**Re: 45 Grenoble Drive Response to Transportation Comments**  
**City File#: 24 253098 NNY 16 OZ**  
**Project No.: 300058194.0000**

R.J. Burnside & Associates Limited (Burnside) has reviewed the City of Toronto (the City) transportation related comments within the following documents:

VEHICLE MANEUVERING ANALYSIS  
CITY FRONT LOAD REFUSE TRUCK

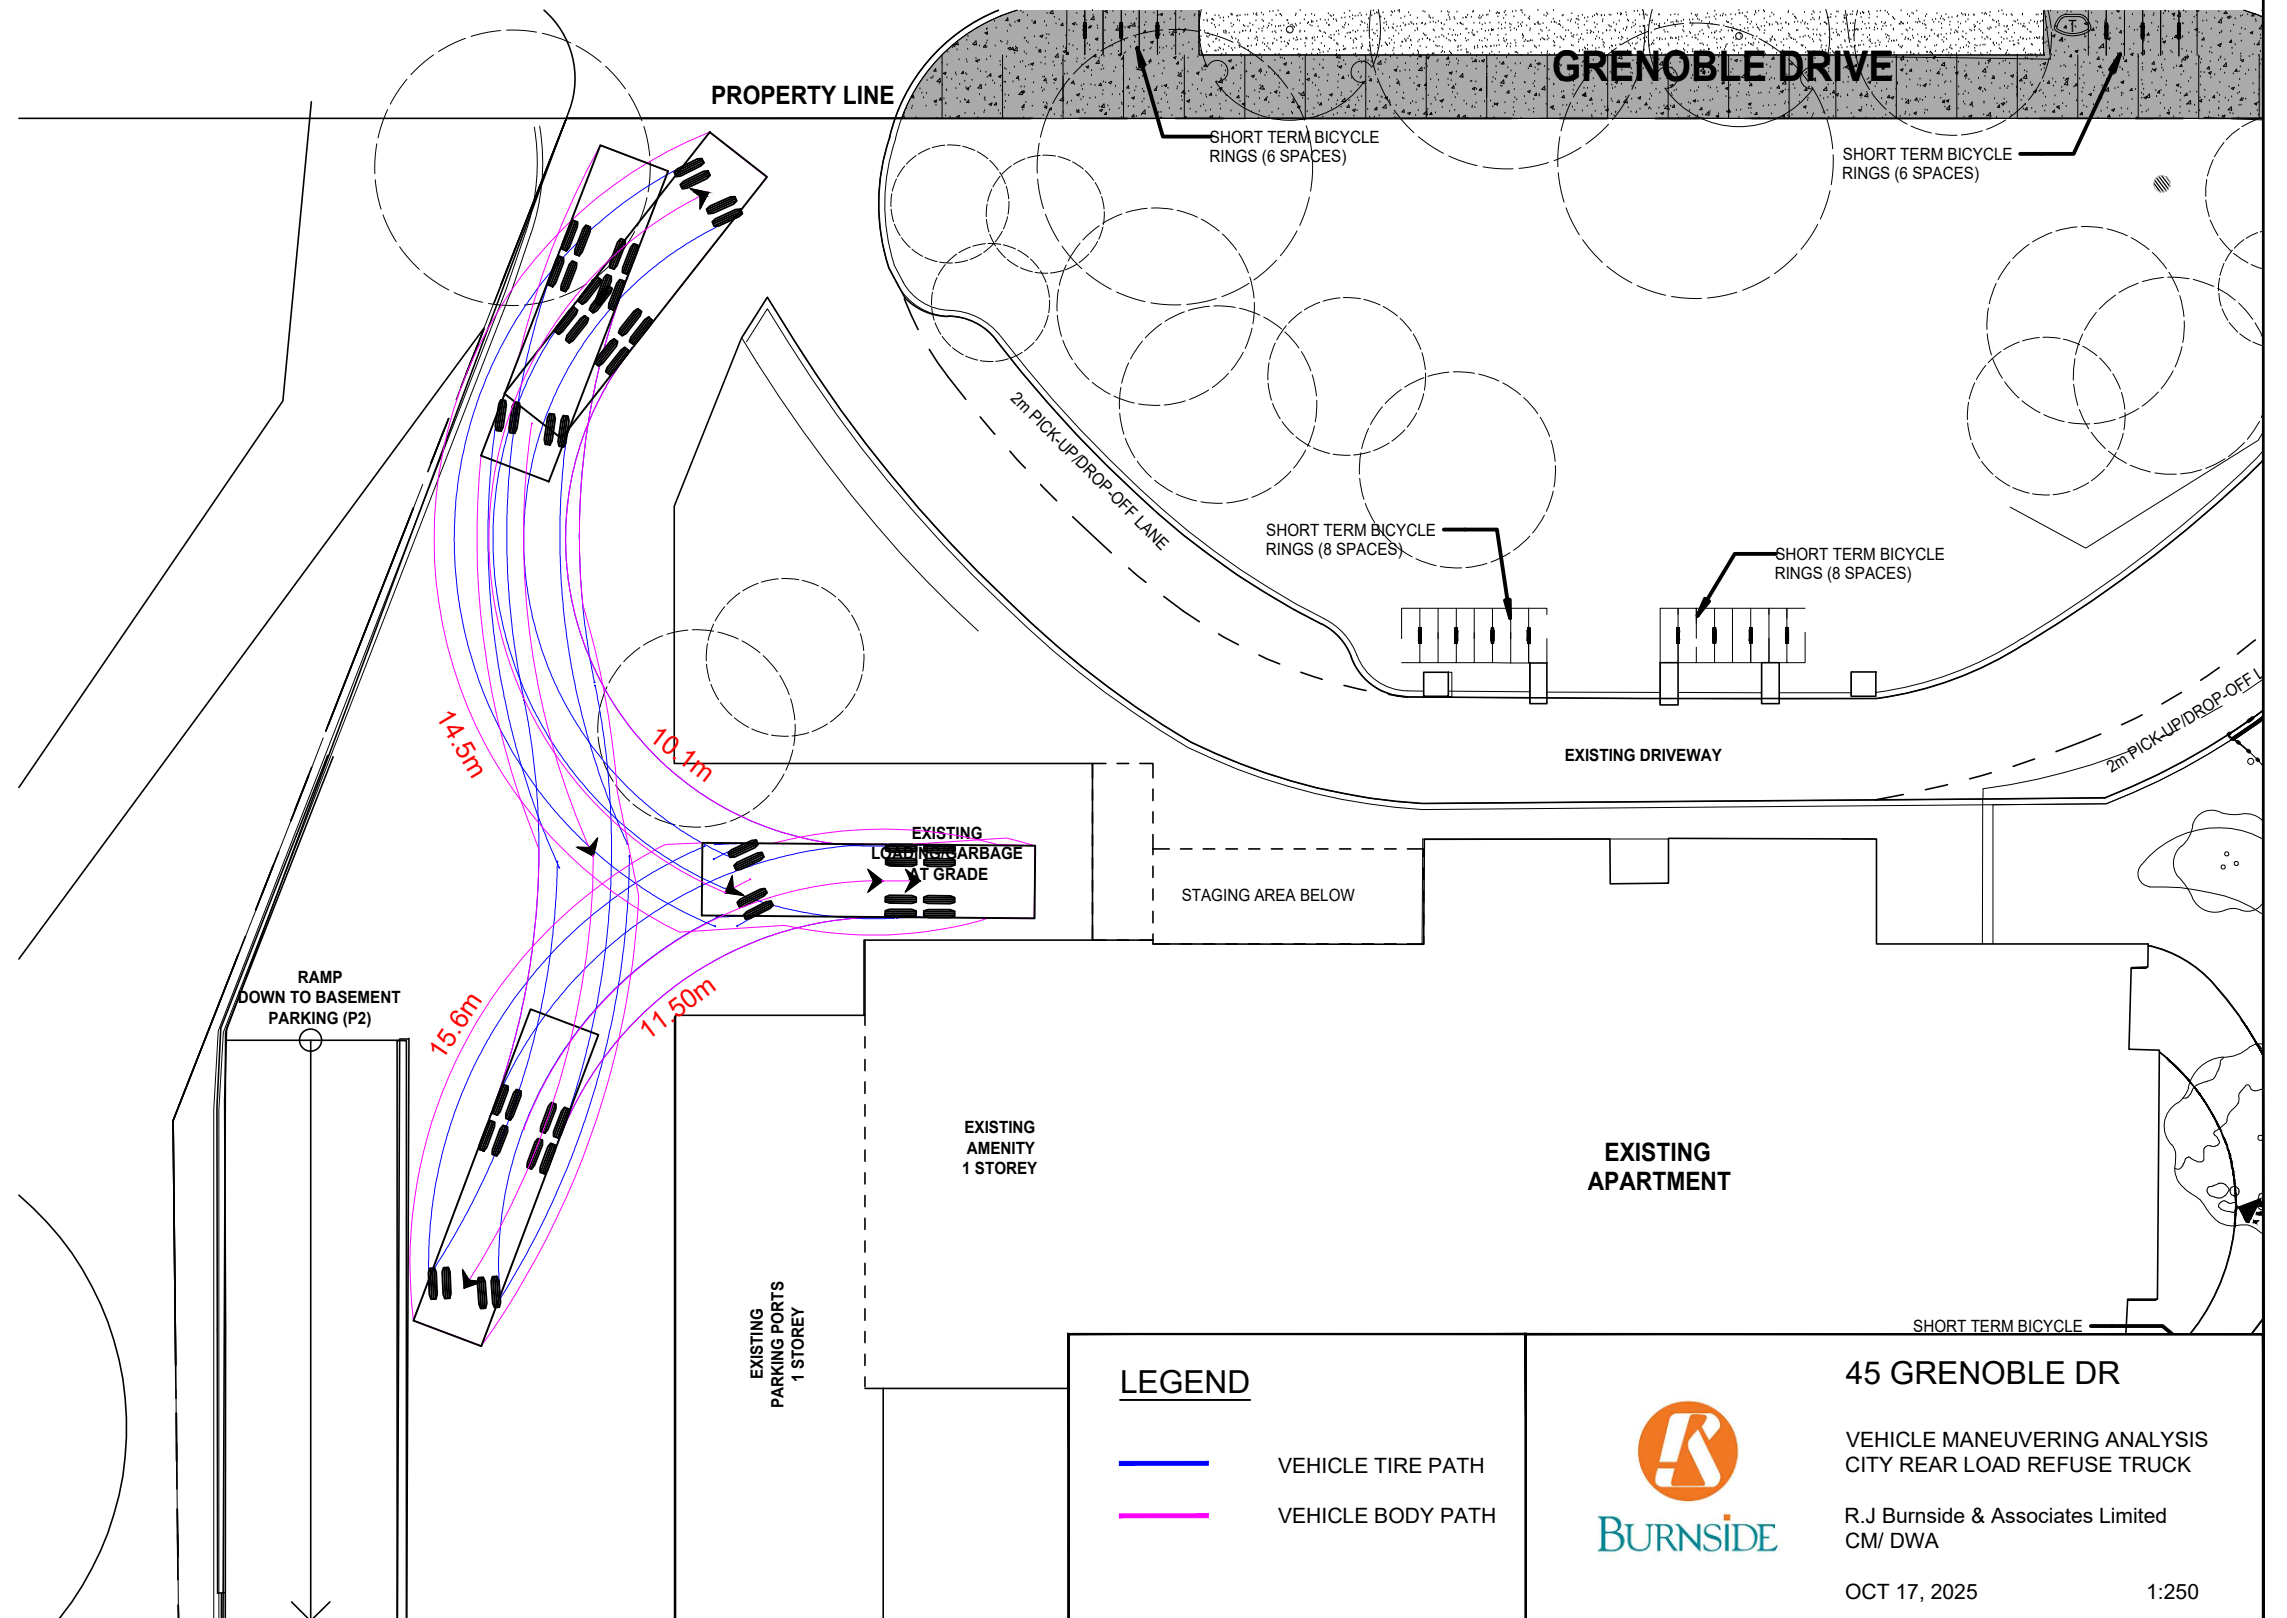
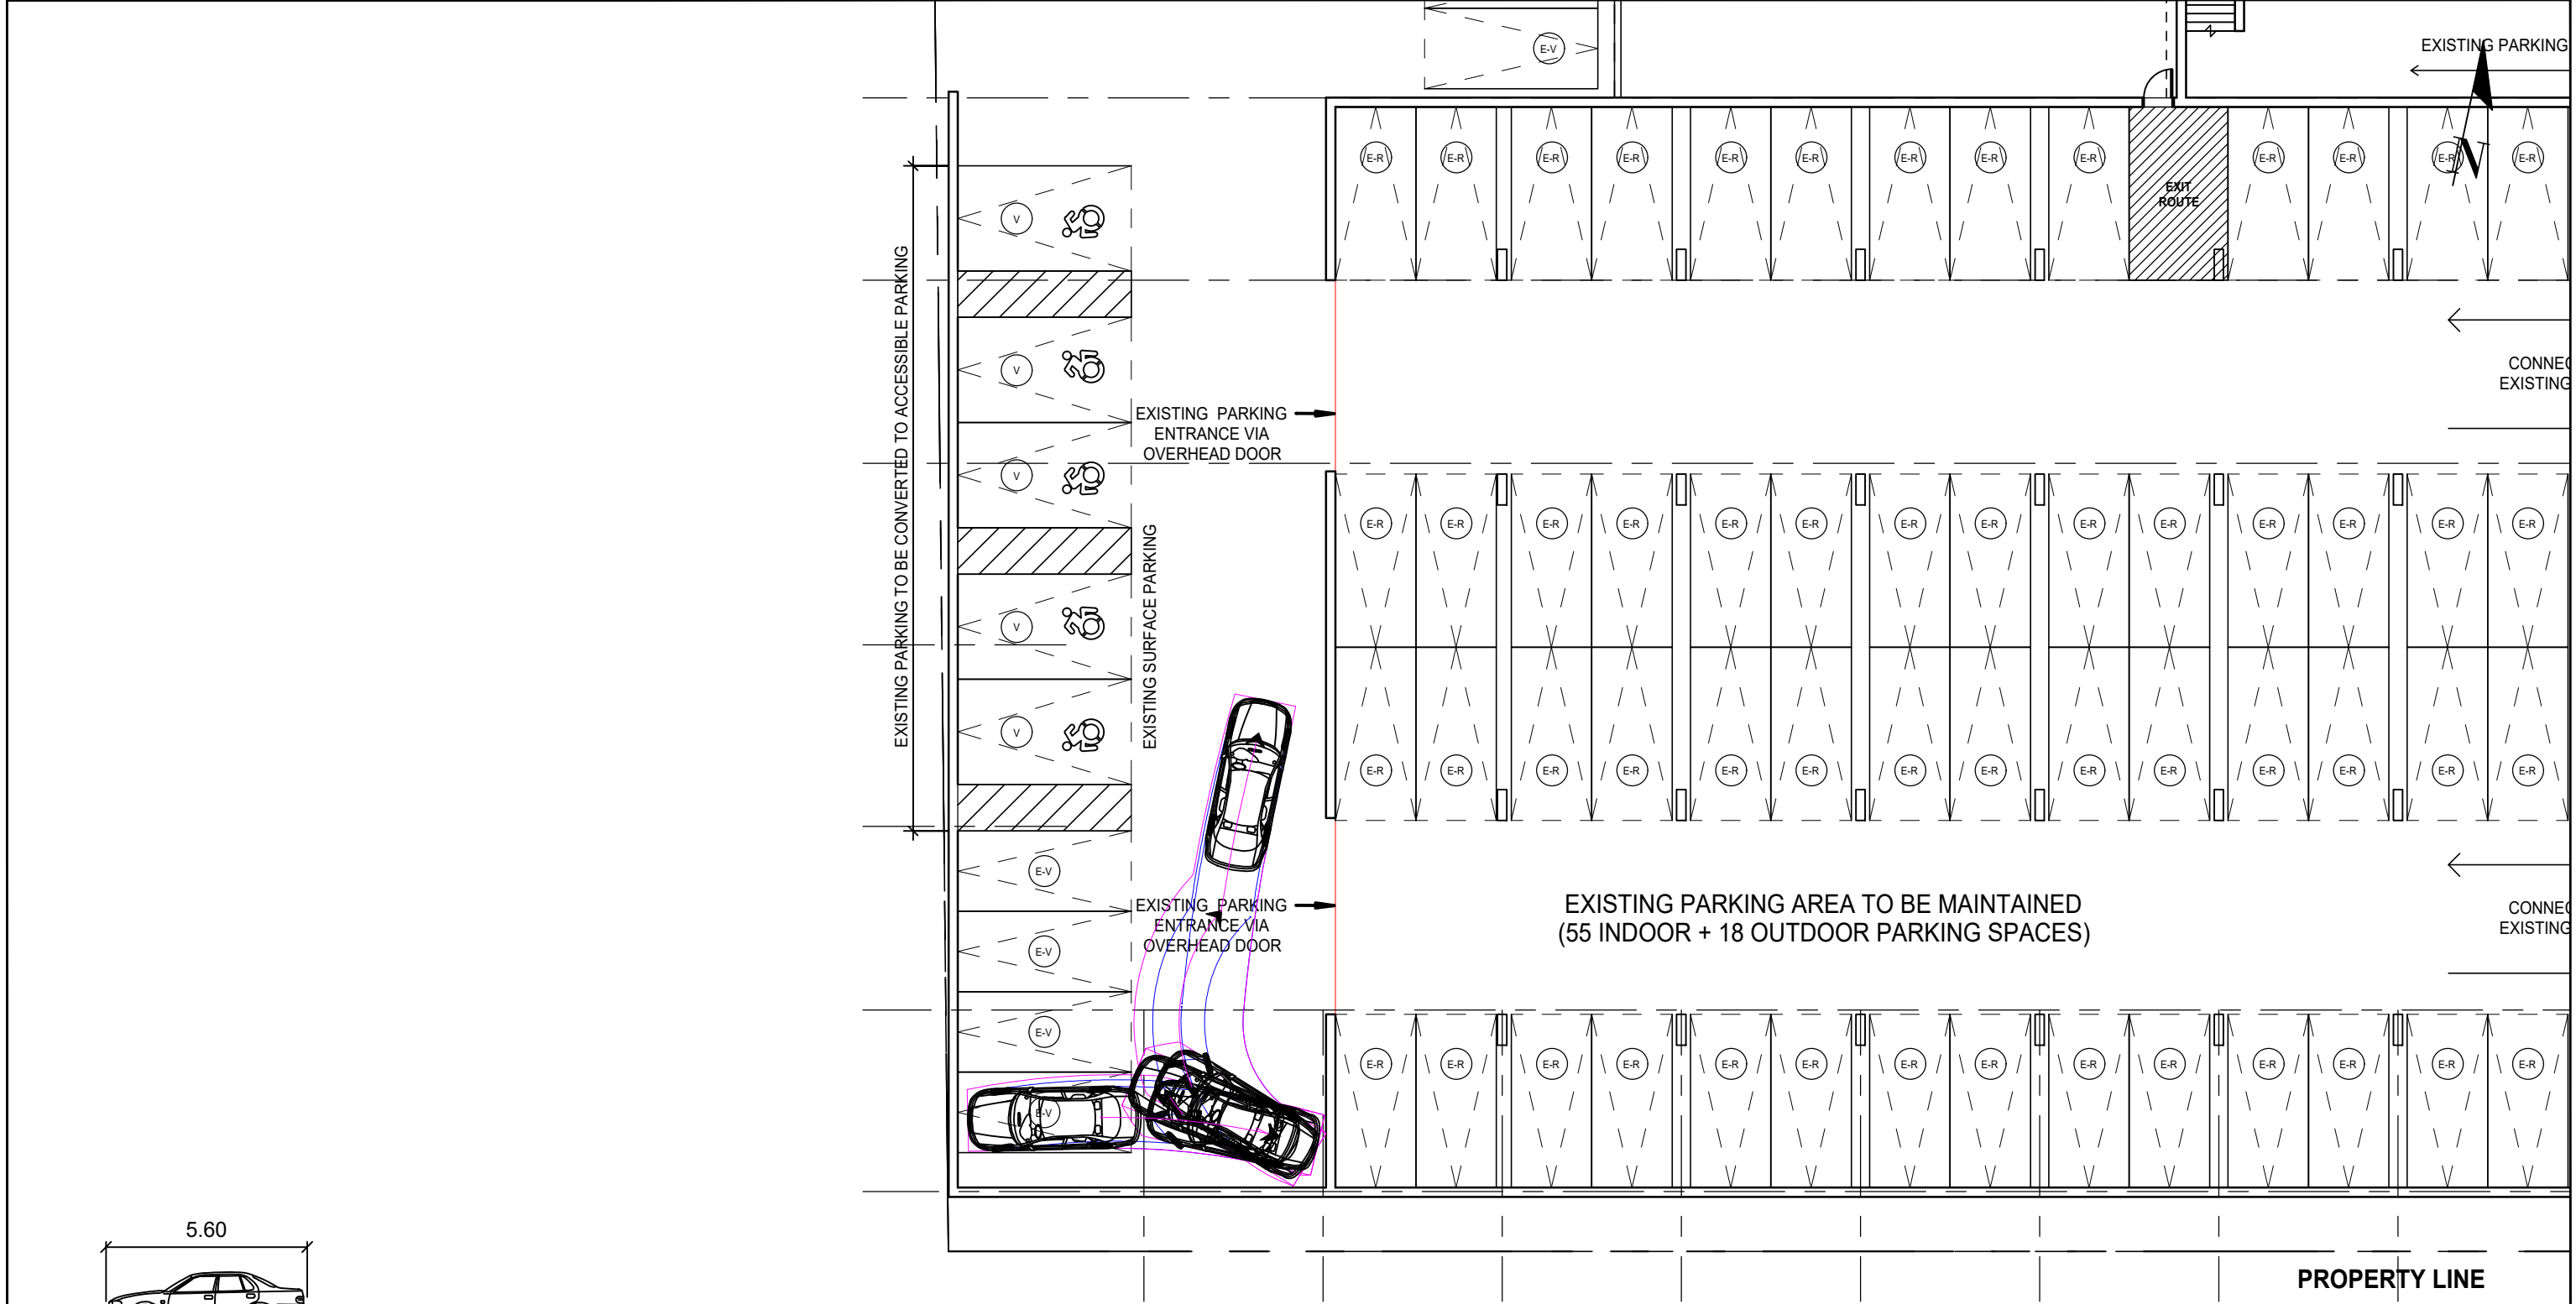
*Provide updated Vehicle Maneuvering Diagrams (VMD) demonstrating heavy vehicles entering and exiting the proposed loading facilities in a forward motion via a consolidated 6.0-meter-wide two-way access driveway onto Grenoble Drive.*

A vehicle maneuvering analysis was conducted in Appendix I of the TIS, which demonstrated the City's front-load and oversized rear-packer refuse trucks can access the existing loading space. A Type C loading space is proposed adjacent to the proposed tower and will accommodate a TAC LSU design vehicle, as shown in Attachment 3.
